ADDENDUM NO. 1

Date: February 6, 2025
Project Name: Taxiway, Taxilane, and Apron Rehabilitation
Airport: Skylark Field (ILE)
TxDOT CSJ No.: 2409KILEN
Garver Project No. 22A06181

GC-102

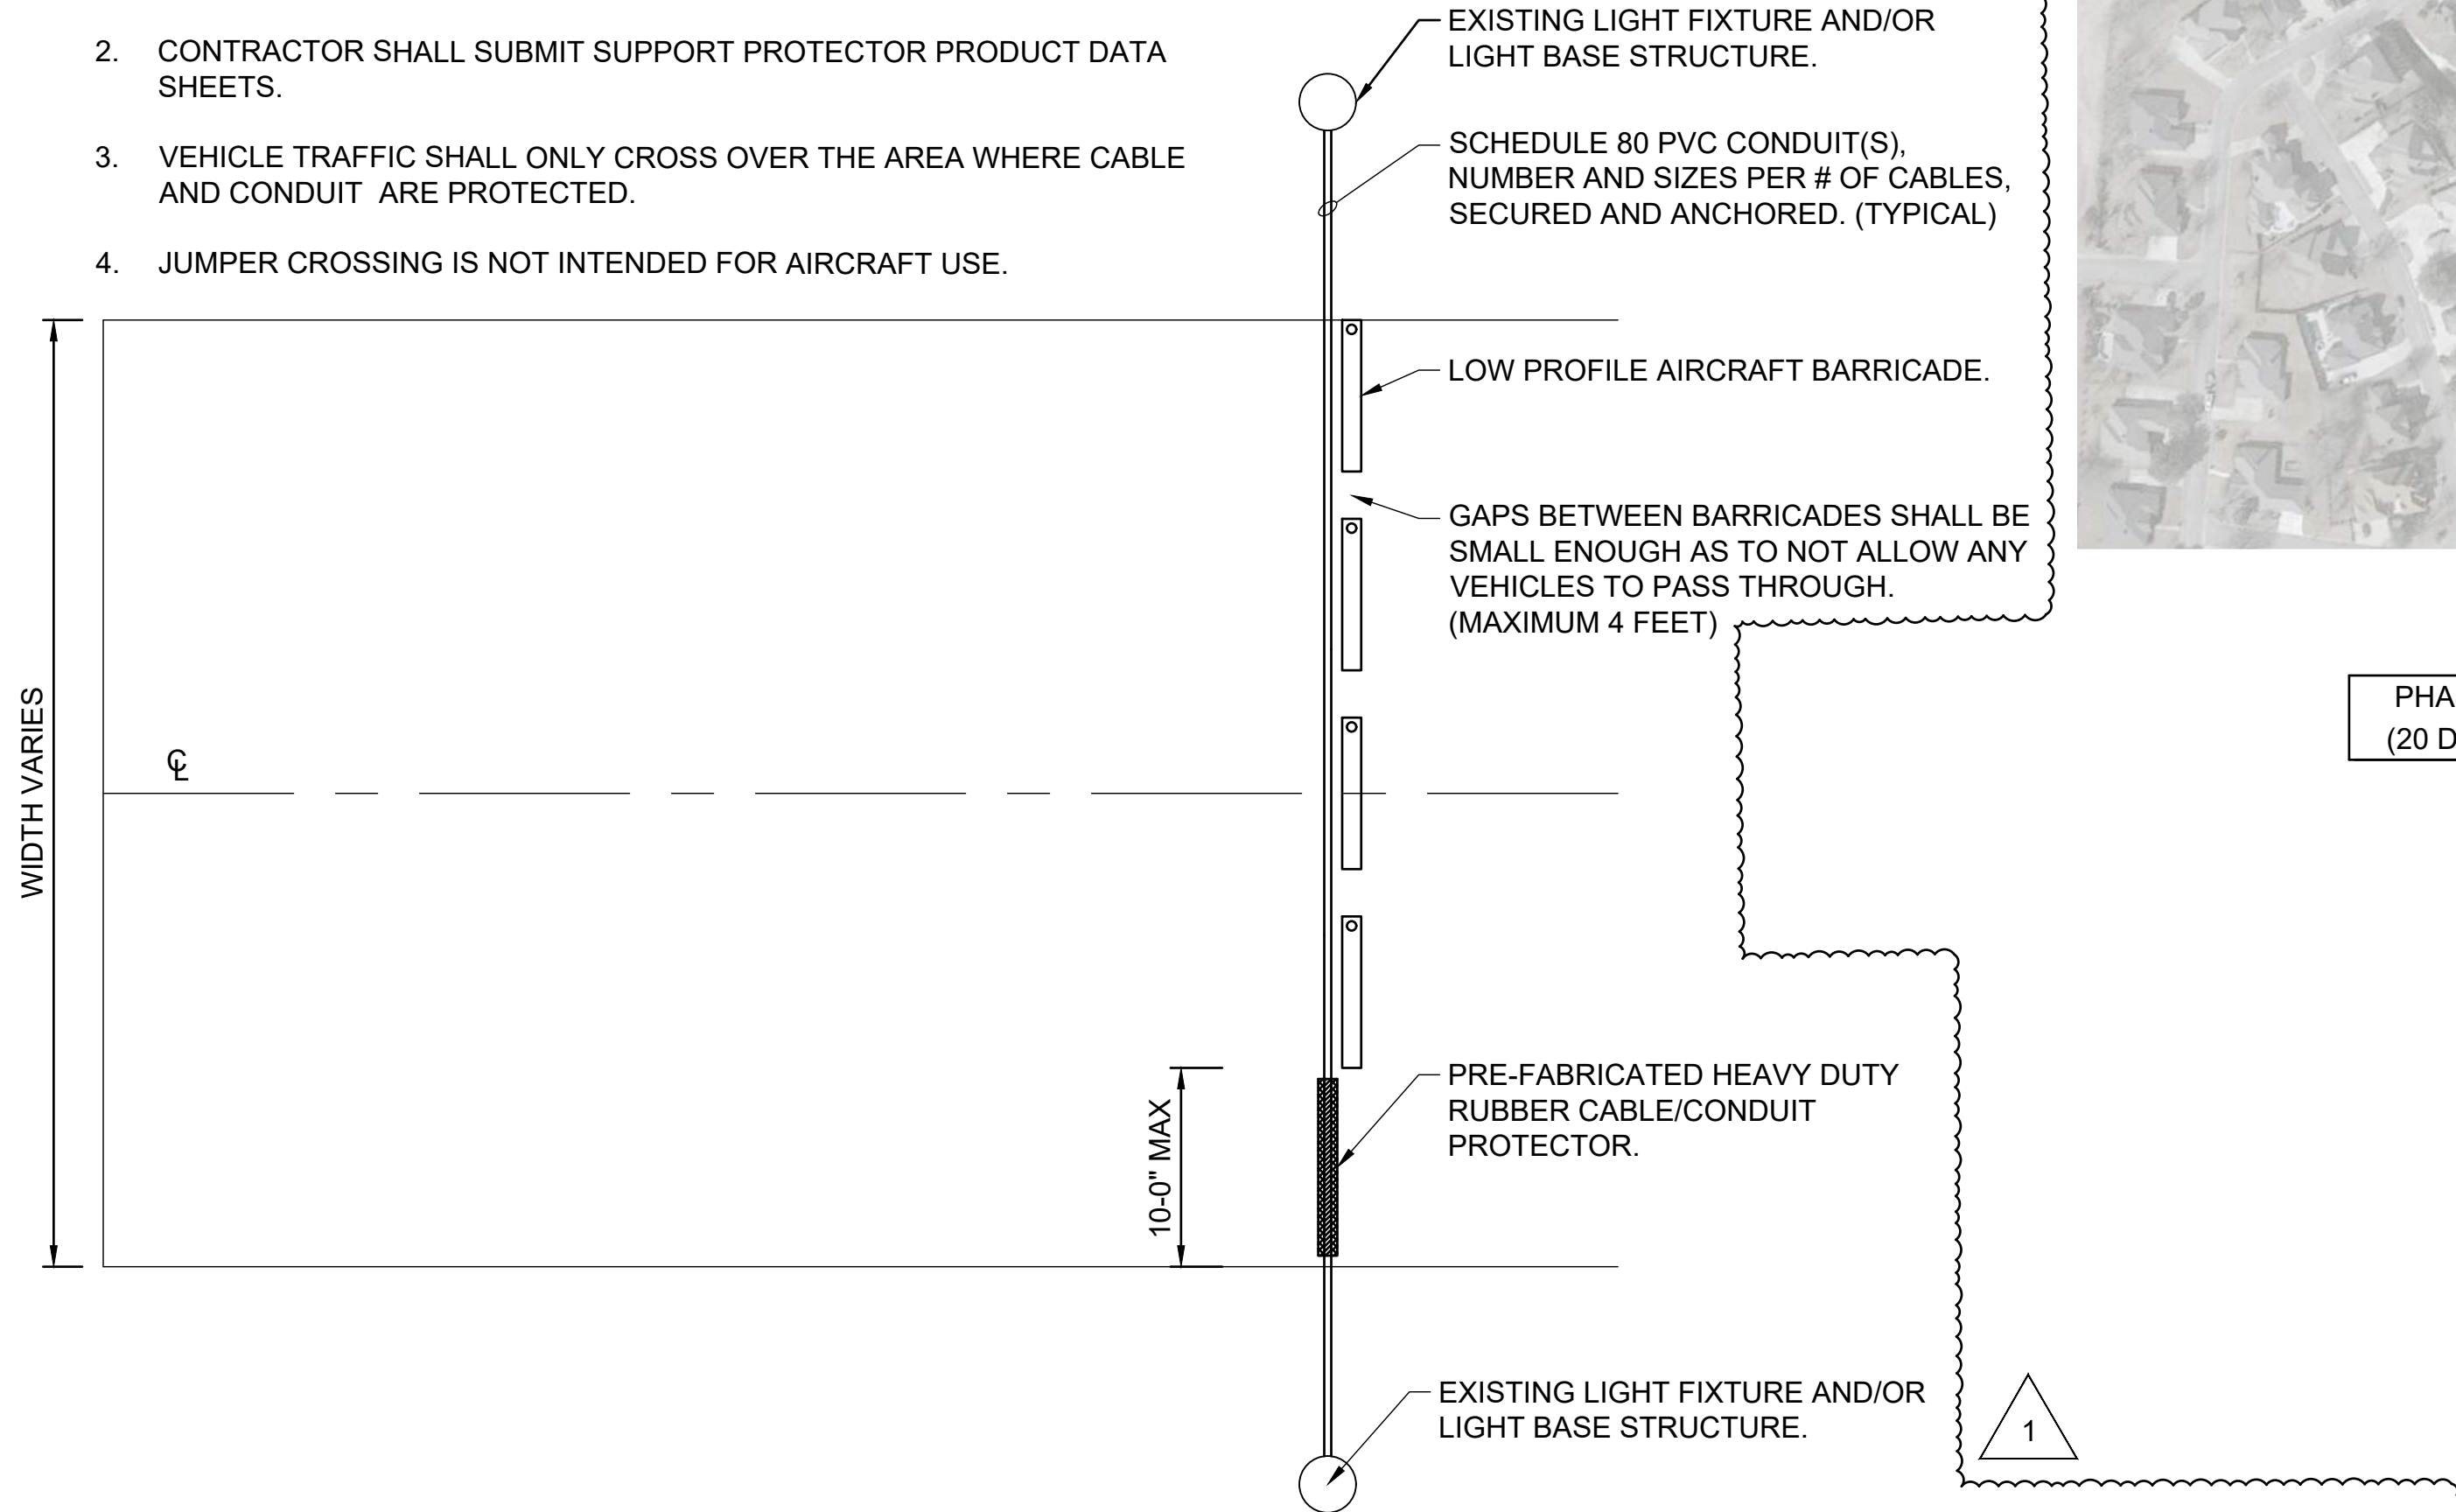
Q: *Would you please provide a drawing showing the project temporary jumper locations.*

A: *Please find temporary jumper locations on the plan sheets included with Addendum #1.*

ABOVE GROUND TEMPORARY CONDUIT PROTECTOR

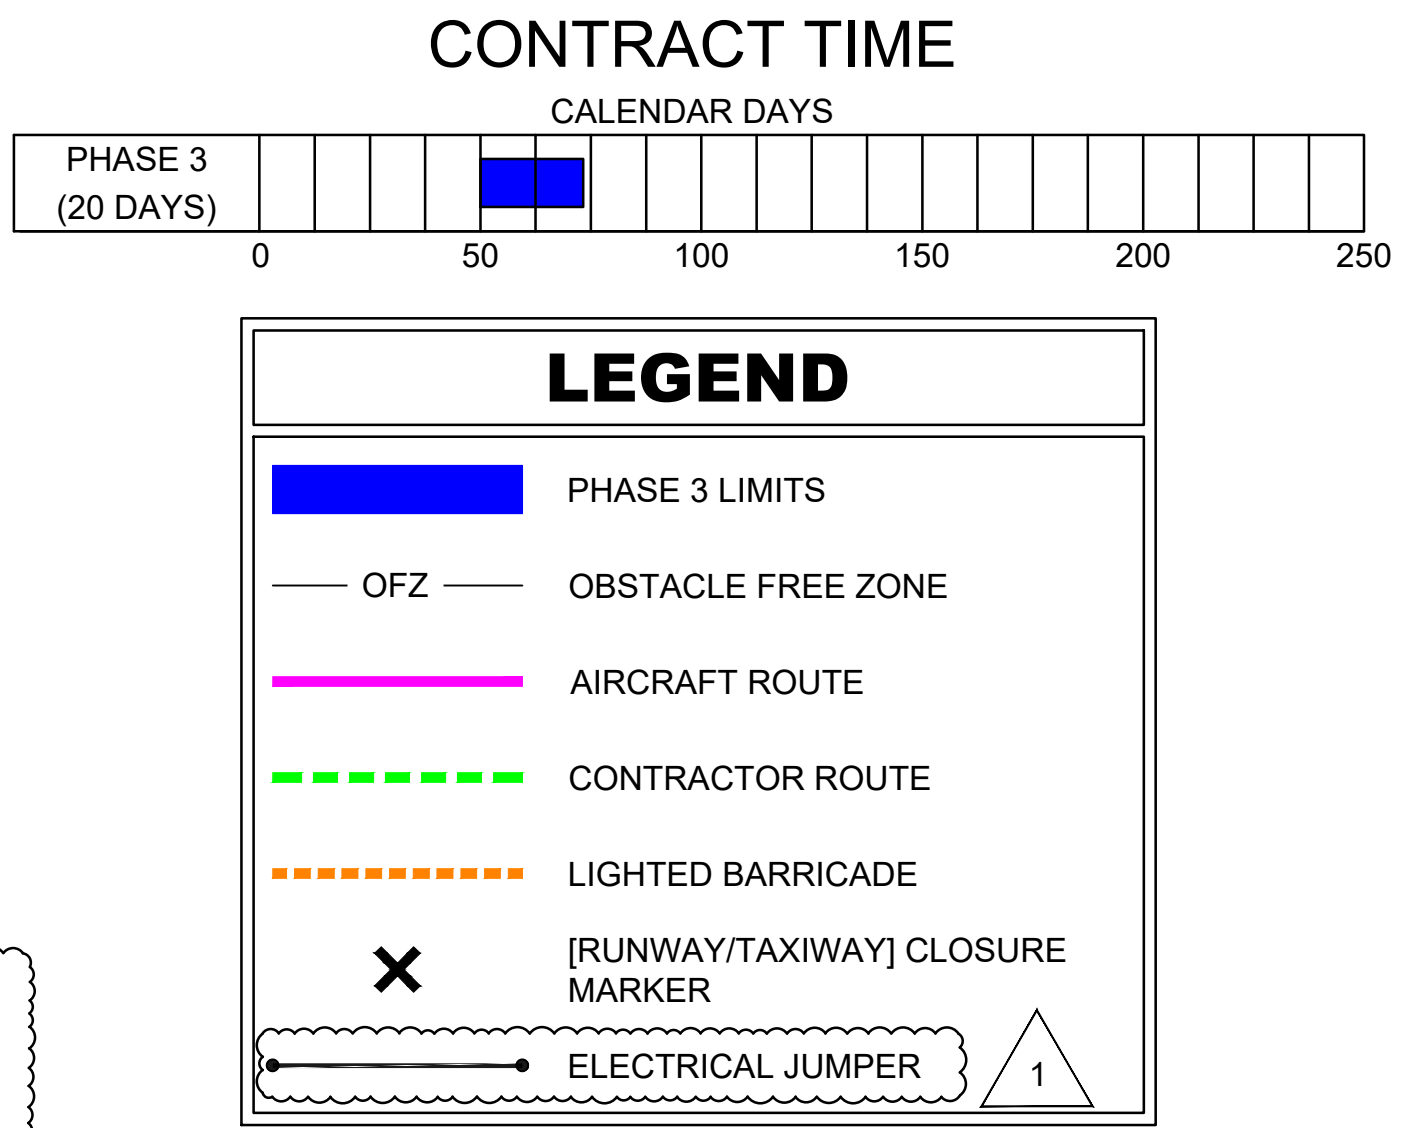
INSTALL NEW OUTDOOR RATED, HEAVY-DUTY, NON-METALLIC, CROSSOVER CABLE/CONDUIT PROTECTOR TO PROTECT CONDUITS AND CABLES RUN ACROSS PAVED SURFACES AND ALLOW SAFE CROSSING FOR VEHICLE AND PEDESTRIAN TRAFFIC, SEE SUPPORT NOTES.

PROVIDE PROTECTOR WITH TOP TREAD PATTERN FOR TRACTION.

1. SIZE CONDUIT PER NUMBER OF CABLES.
2. SIZE PROTECTOR PER CONDUIT NUMBER AND SIZES.
3. PROTECTOR SHALL EXTEND PARALLEL TO THE CONDUIT FOR THE ENTIRE LENGTH OF THE CONDUIT WHERE SUBJECT TO LIGHT VEHICULAR TRAFFIC.
4. BOLTS SHALL BE INSTALLED AND TORQUED PER MANUFACTURERS RECOMMENDATIONS TO SECURE AND ANCHOR THE COMPLETE PROTECTION SYSTEM.
